Walter E. Deuchler
Associates, Inc.
CONSULTING ENGINEERS

MEMORANDUM

RE: Stafford Place Development, Warrenville, IL

As requested, we have completed a review of the following documents:

Prop. Conditions Tributary Area Exhibit

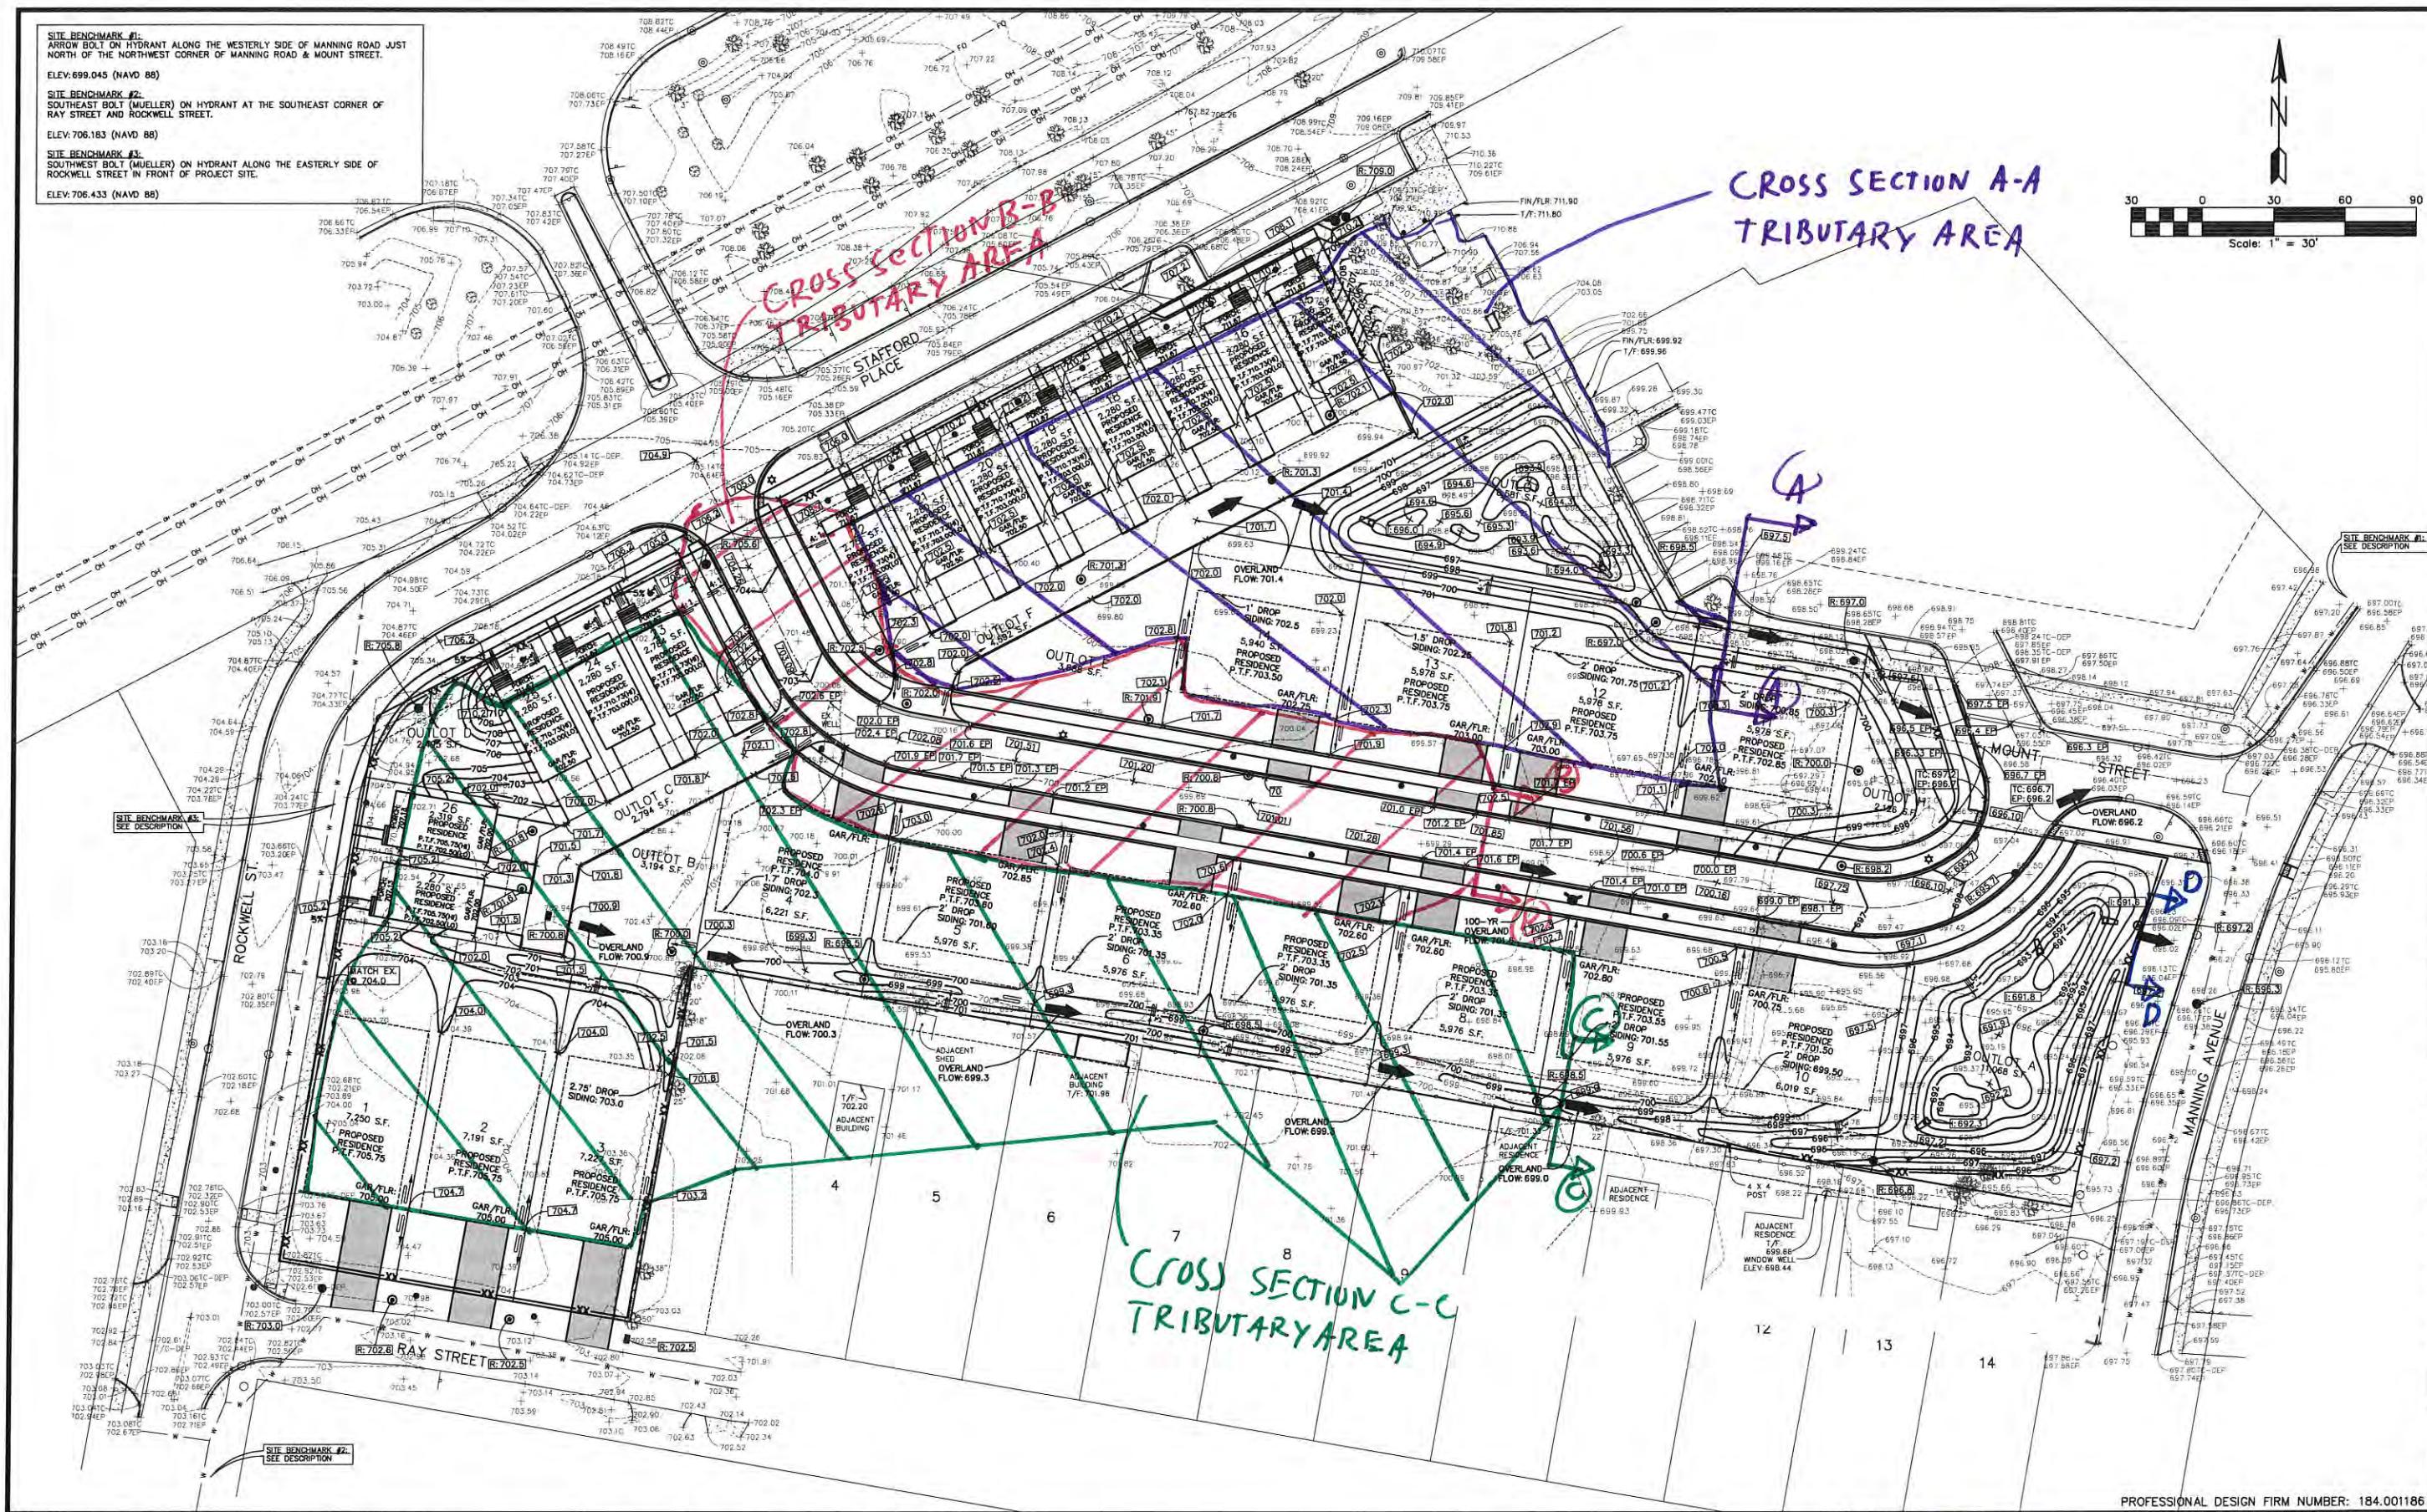
Overland flow routes have also been provided to convey runoff for a 100-year storm. Storm runoff tributary to the northerly PCBMP basin (Outlot G) is being conveyed via a proposed swale along the north property line to Mount Street. Storm runoff tributary to the proposed extension of Mount Street is being conveyed onto Mount Street and then easterly along the road to Manning Avenue. The proposed 100-year storm overland flow routes have been designed with excess capacity. Overland flow routes were also coordinated with the proposed landscaping plan to avoid potential blockage.

See Attachment No. 4 for proposed tributary areas, overland flow routes and overland flow calculations. No impacts to adjacent properties are anticipated.
